## **DRAFT REPORT**

### **2<sup>nd</sup> meeting of GRRF Informal Working Group on Automatically Commanded Steering Function**

Venue: Jasic Office Tokyo, Japan.  
Chairman: Mr. Christian Theis (D) and Mr. Hidenobu Kubota (J)  
Secretariat: Mr. Jochen Schaefer (CLEPA)  
Dates: 16.-17. June 2015  
Website: <https://www2.unece.org/wiki/display/trans/ACSF+1st+session>

## 5. Attention recognition (2.4.8.13)

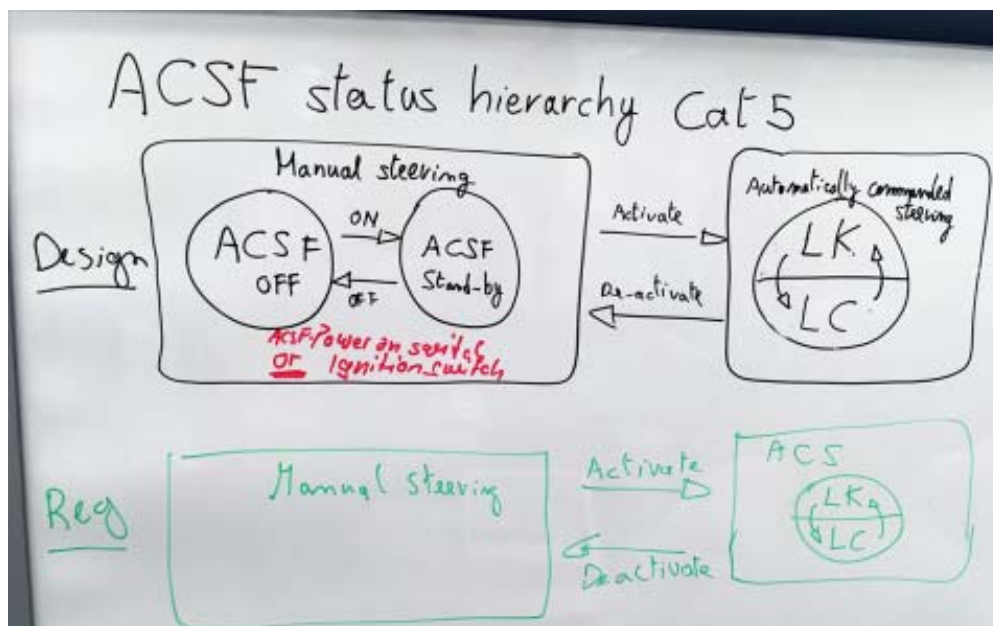
OICA: Attention of the driver cannot be detected.

Only "secondary criteria" e.g. closed eyes, looking to the side, can be detected
